Subject: Description of Permissive Change

FCC ID: 2AZJ6TPXXC020AO

Model: G117P38MO5DUO

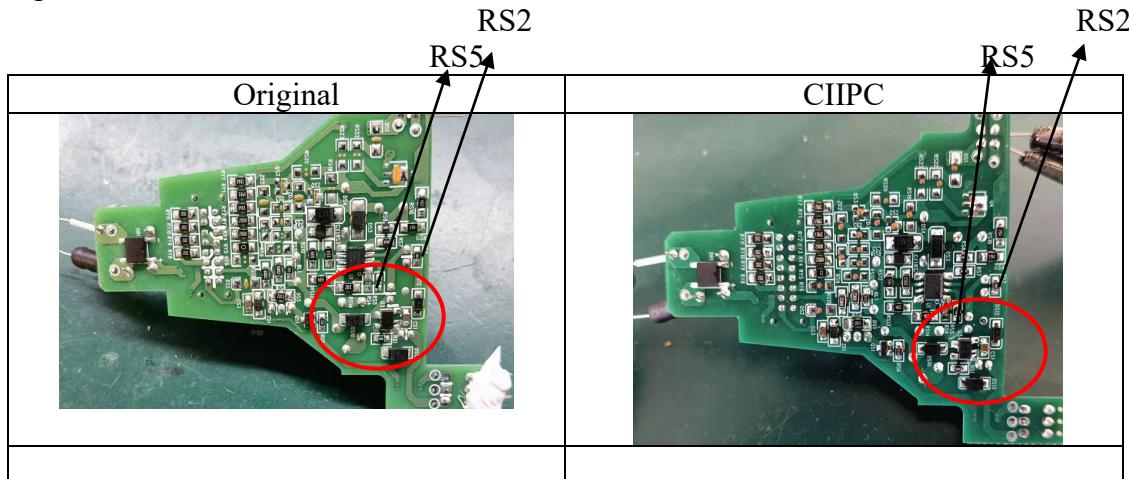
1. RS2 independently connects a wire to the VCC PIN of the module, in order to reduce ripple interference brought by the drive and make the template performance more stable;
2. There was no resistance placed at this position on PCB before, so increase the resistance by 62K (RS5)
3. The above change will not affect RF parameters.
